ADDENDUM NO. 5

DATE: August 26, 2025

RE: Sewer Transfer Project

1. The following sheets shall be deleted and replaced with the attached updated drawing:
 - a. D-101, D-102, D-301, D-302, D-303, D-501
 - b. S-102, S-301, S-402, S-504
 - c. M1-1, M3-1
 - d. E1-1, E2-1, E3-1

PUMP LEVEL PIPING PLAN

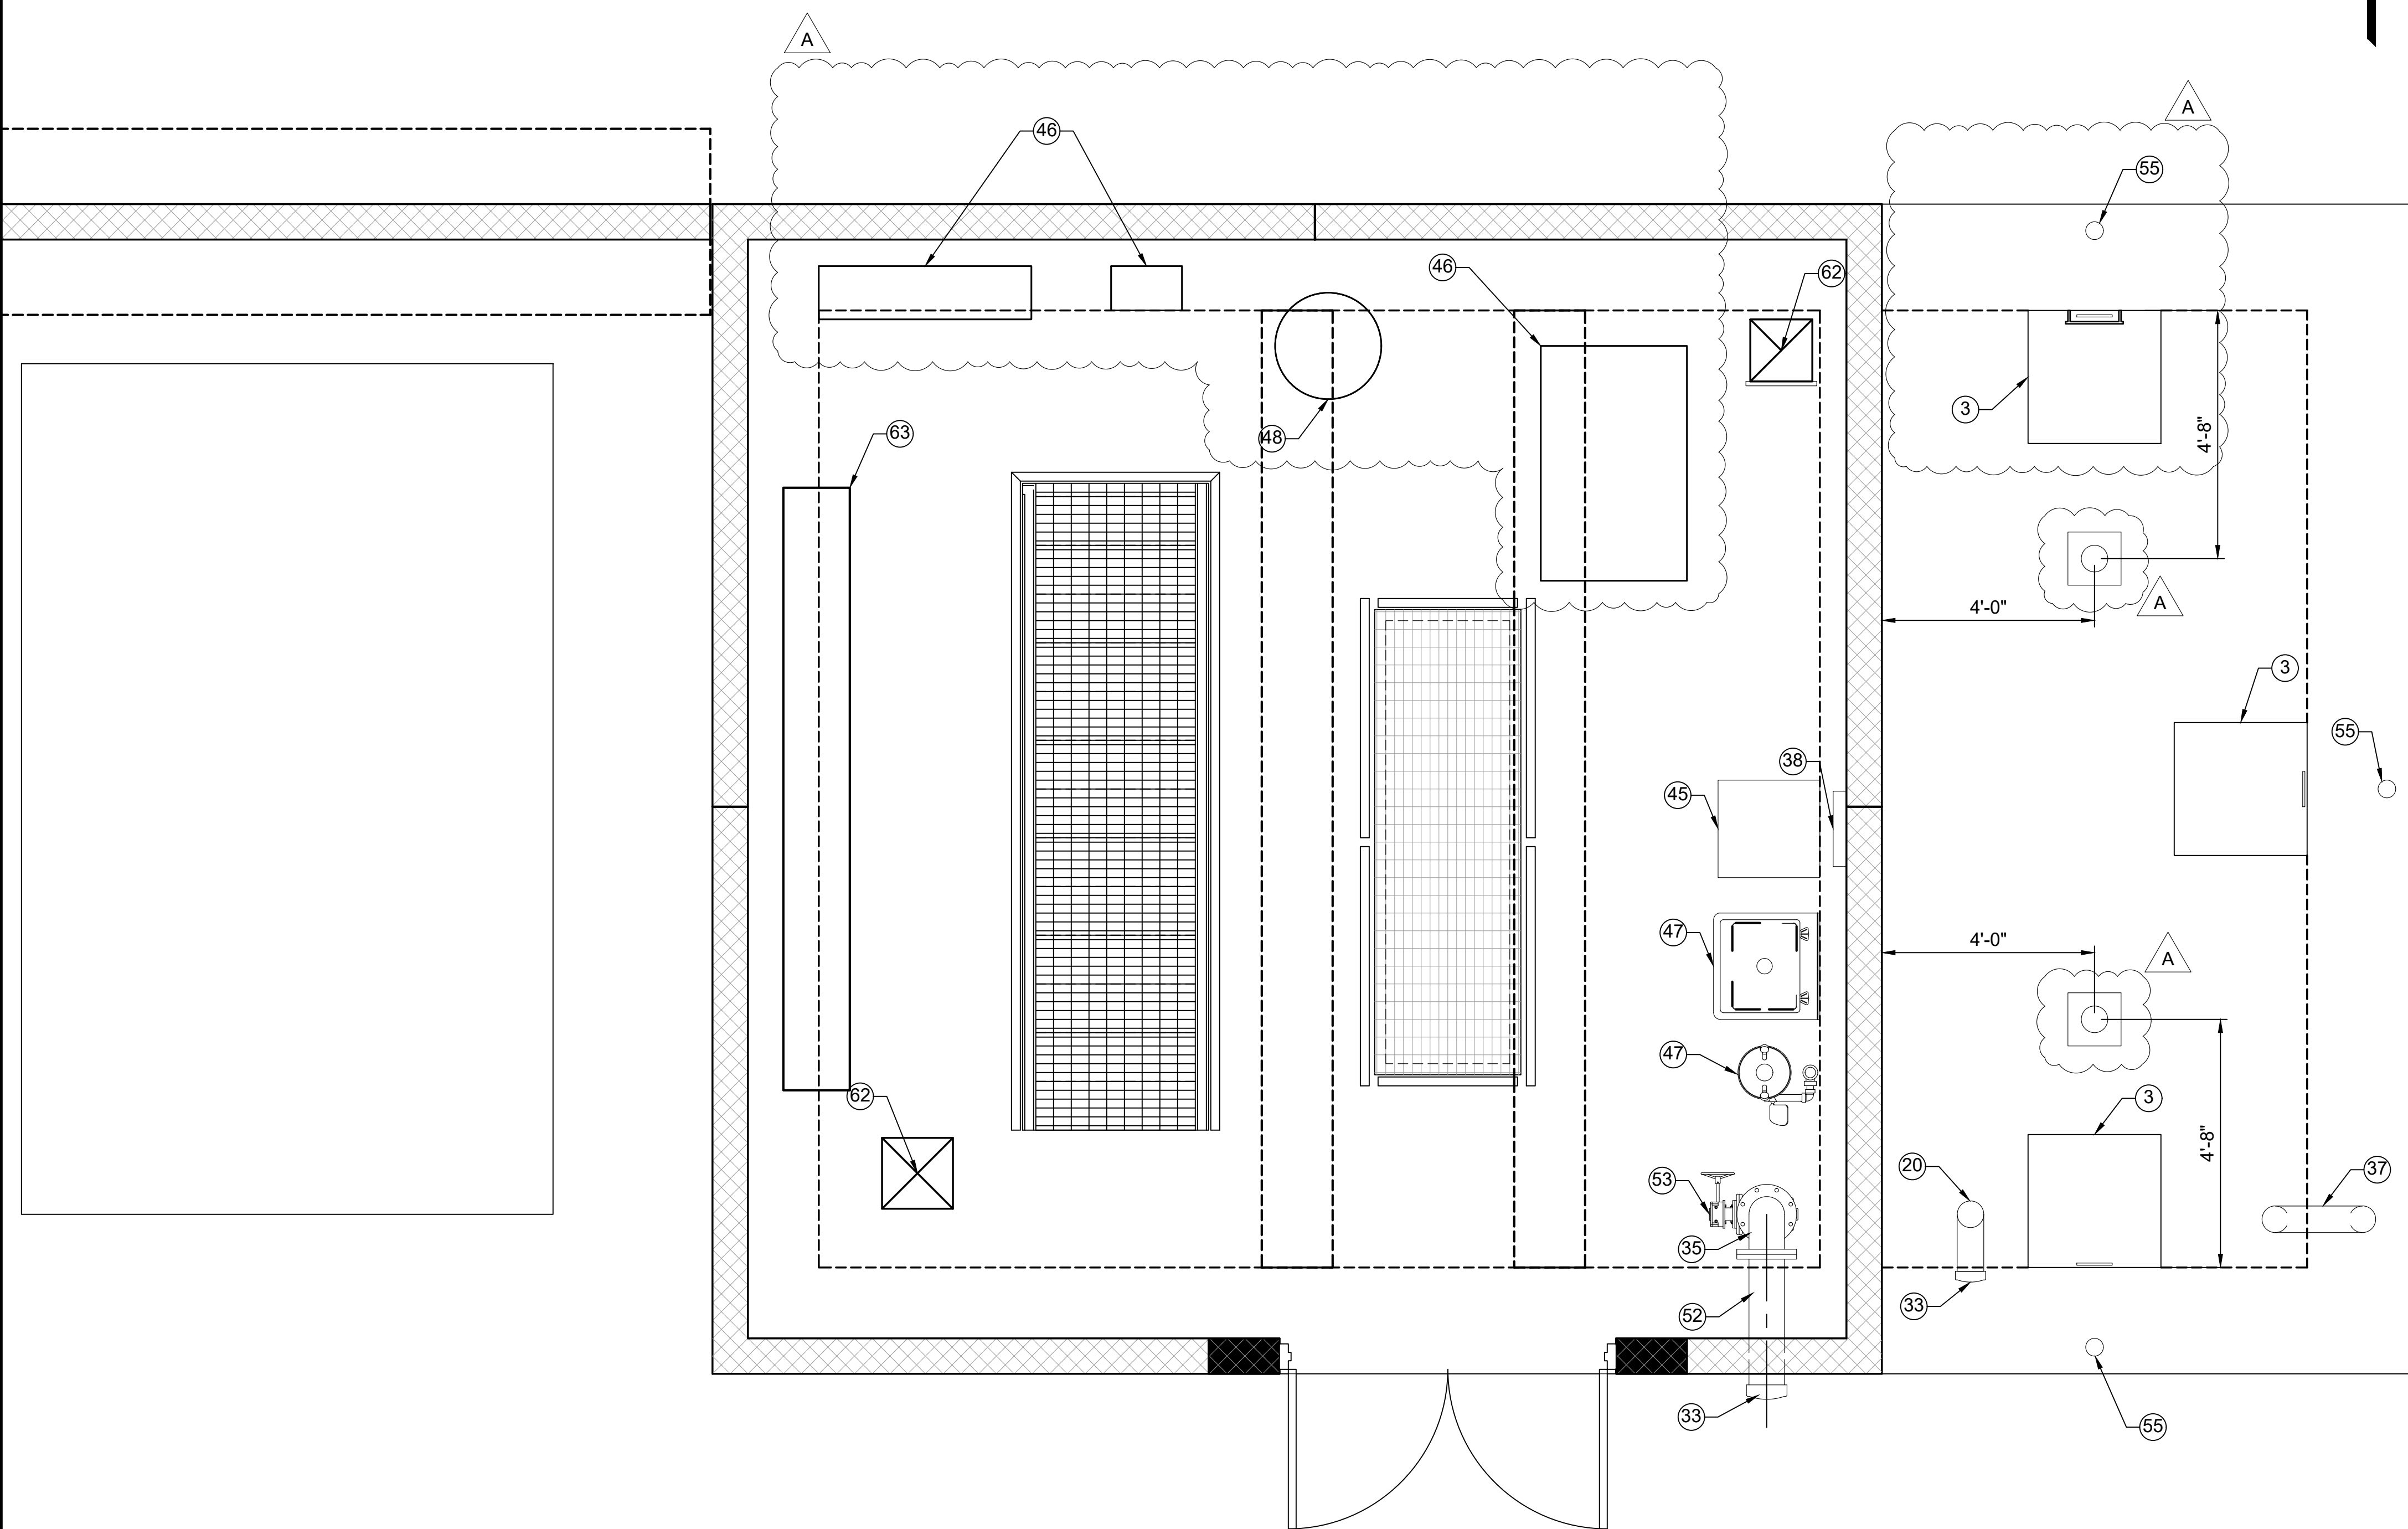
REVISION				
A	REVISED ODOR CONTROL EQUIPMENT & LAYOUT	JDM	KR	8-20-25

MAIN LEVEL PIPING PLAN

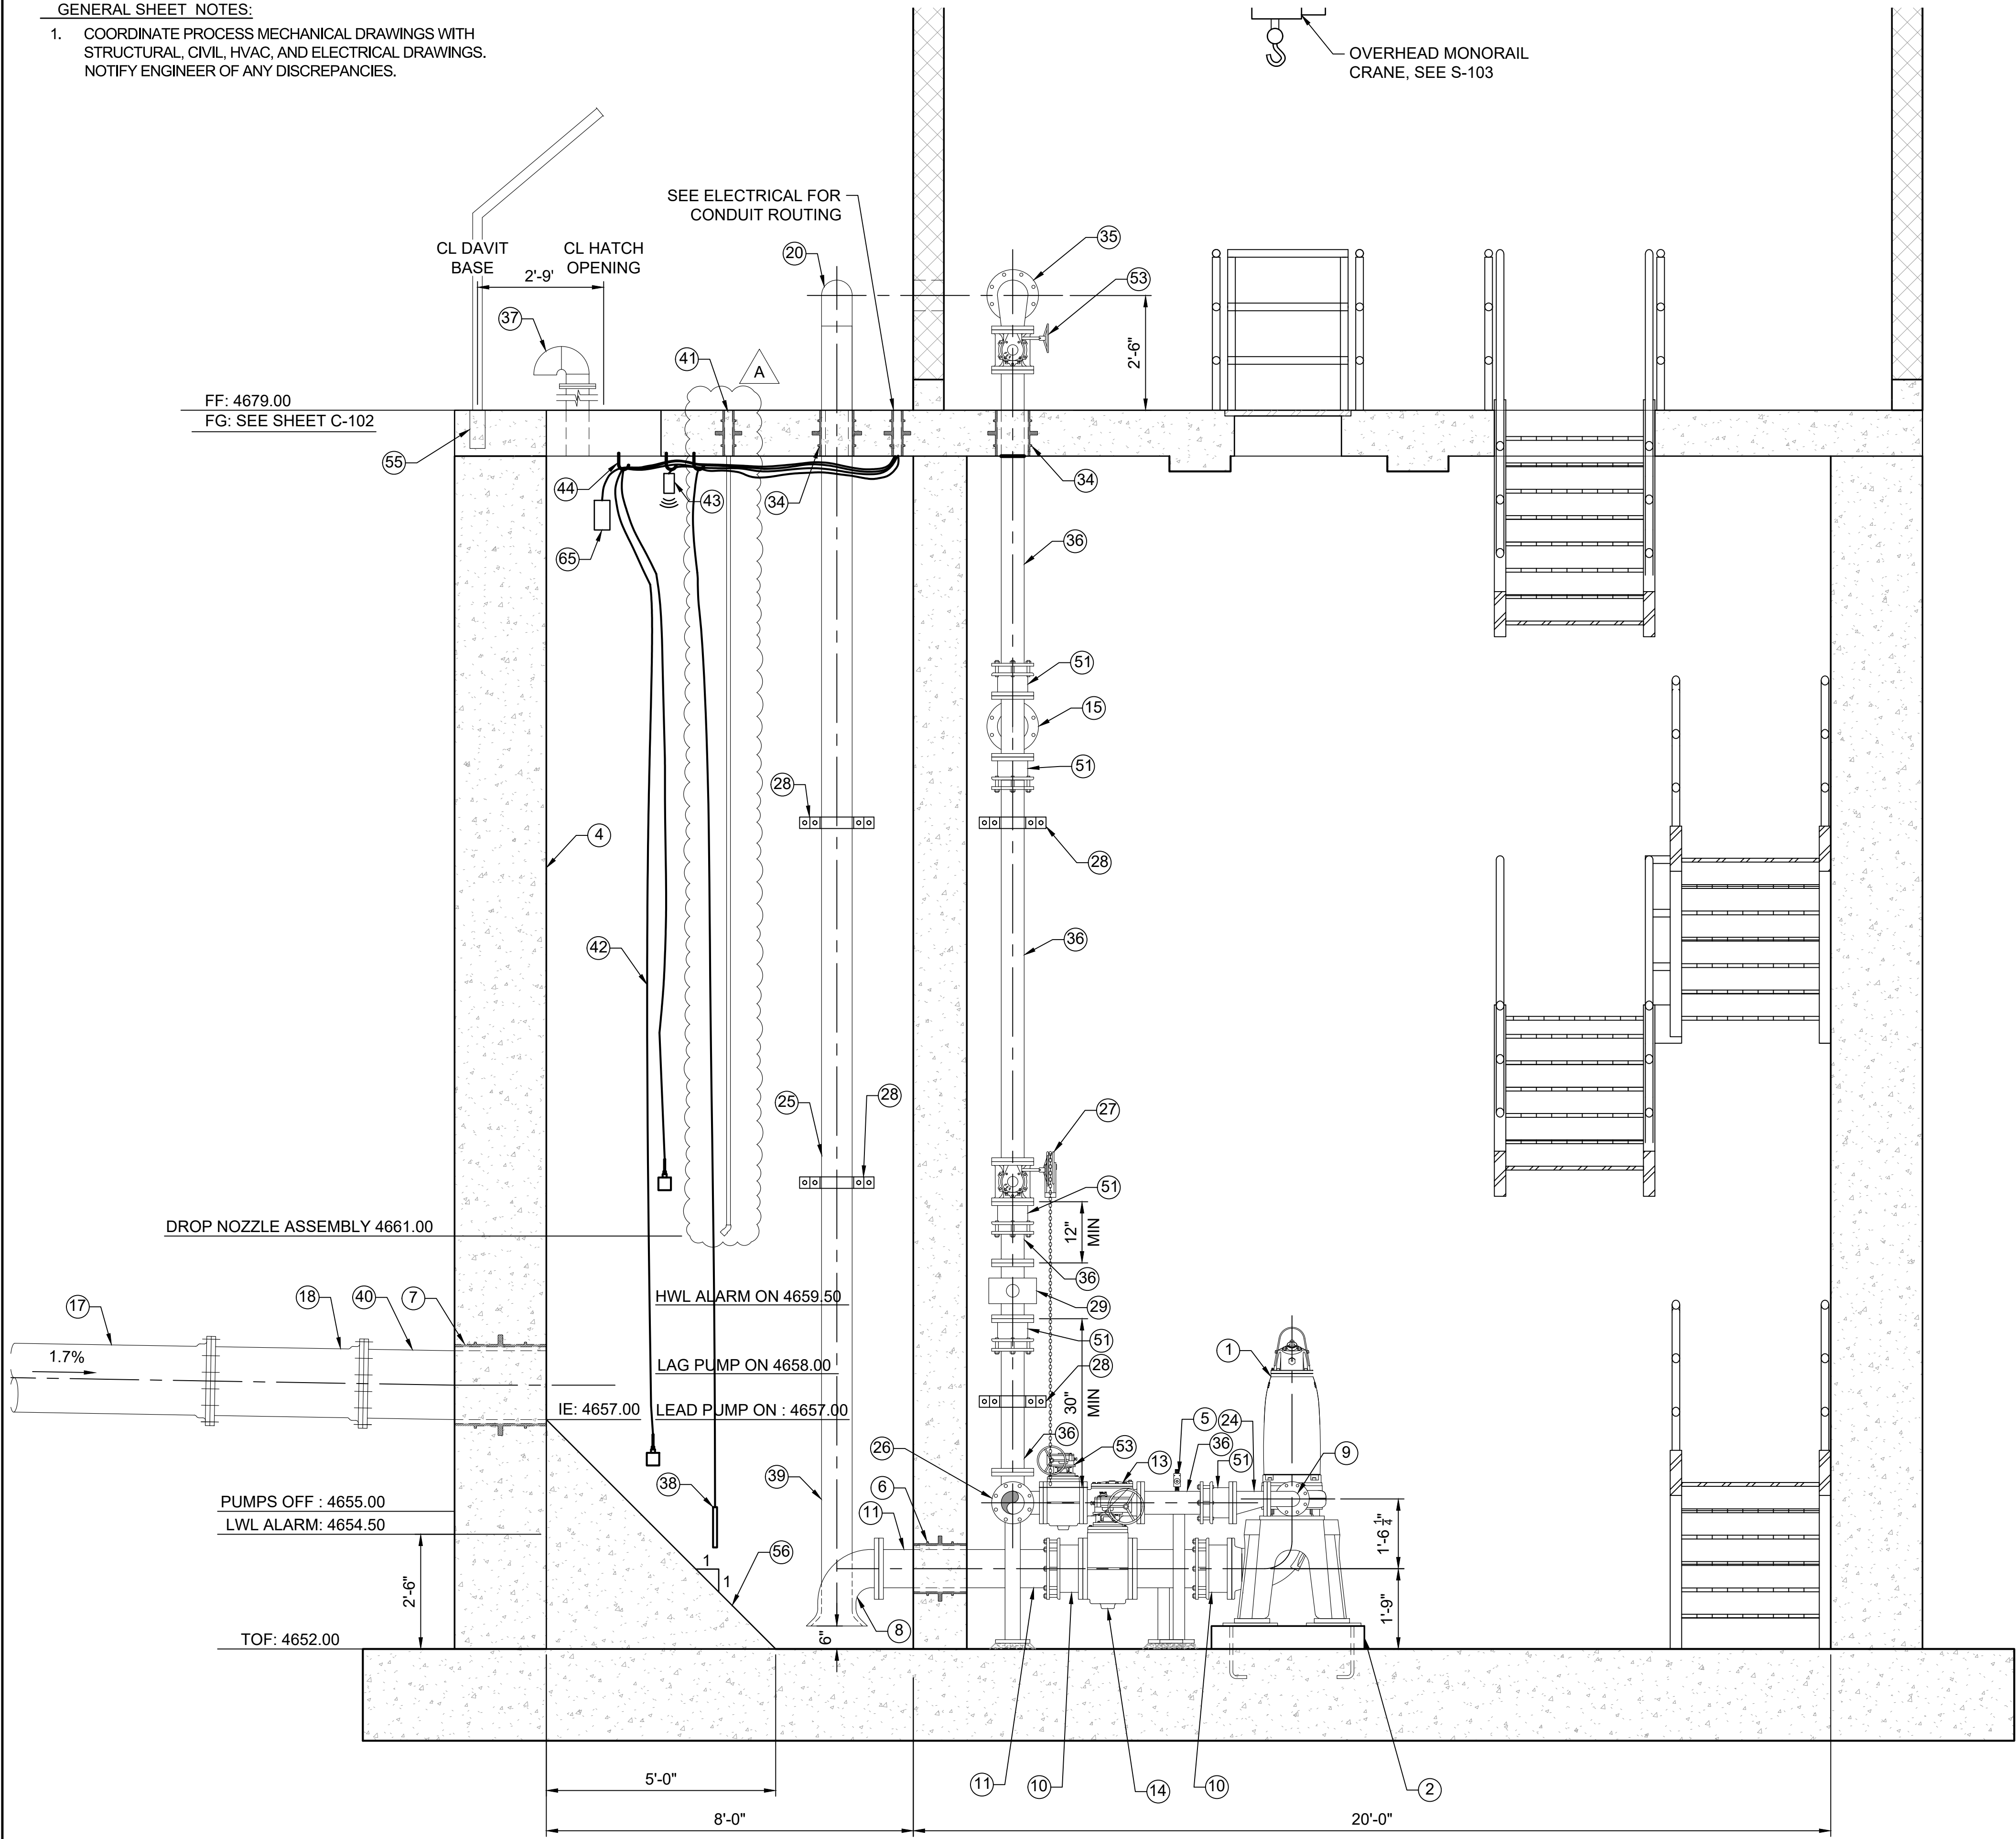
REVISION			
A	REVISED ODOR CONTROL EQUIPMENT & LAYOUT	JDM	8-20-25
